Yesler Terrace Pocket Park

May 7, 2015

((Schematic)) Concept
Design

Figure 2. Site plan for the original pocket park configuration at the corner of E Fir St and 10th Ave (left) and the proposed reconfiguration along the entire E Fir St frontage (right).

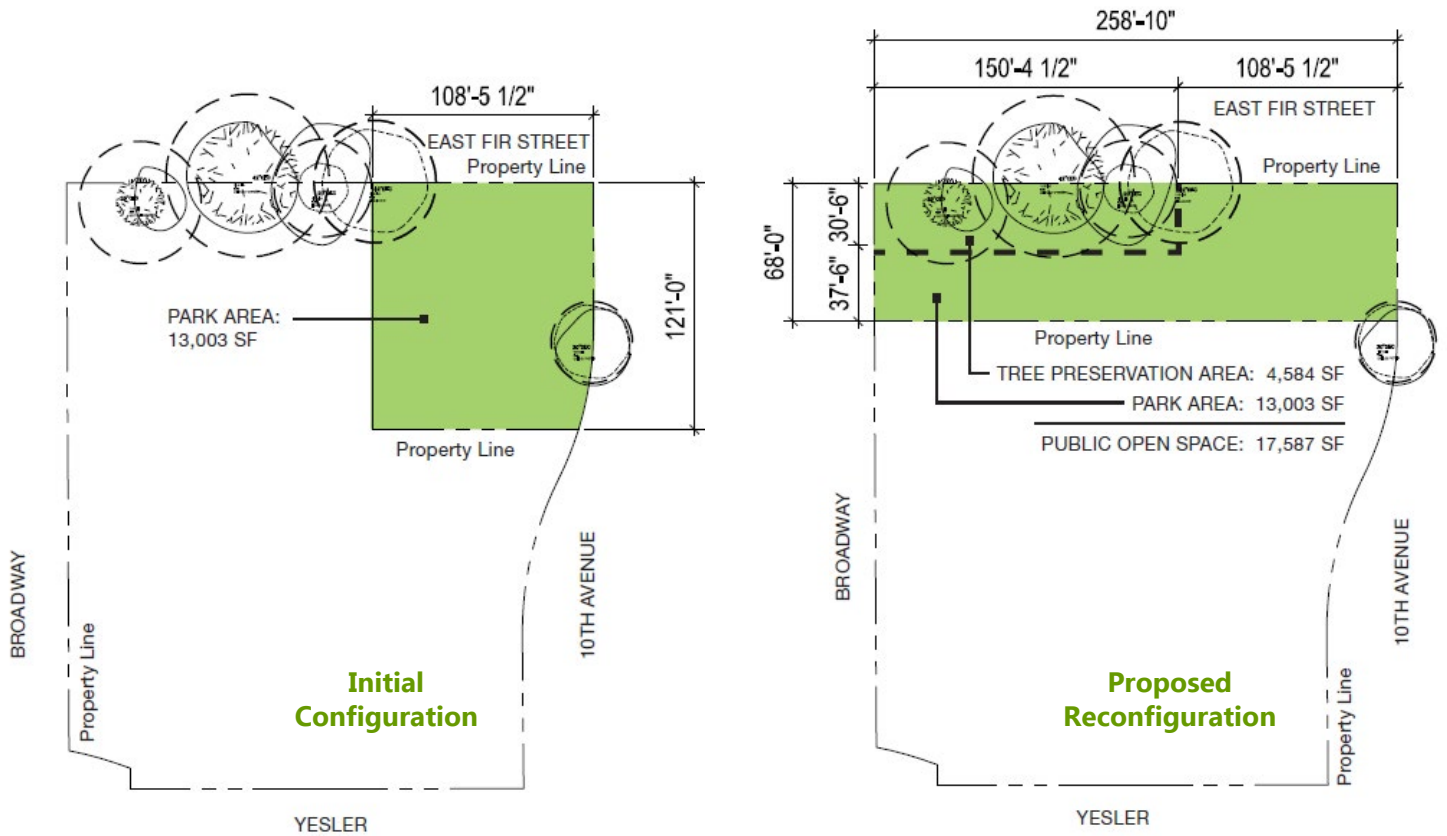
The Commissioners were supportive of the ((schematic)) concept design for the pocket park. They also supported SHA's request to reconfigure the park because it allows for preservation of existing trees, expanded visibility of the pocket, increased sun exposure, and creation of a frontage on Broadway.

Furthermore, the Commission supported the decision to reorient the park from its original configuration as a 13,000-square-foot open space in the northeast corner of the block to its proposed configuration as a 17,000-square-foot open space along the entire north edge of the block, as shown in Figure 2.
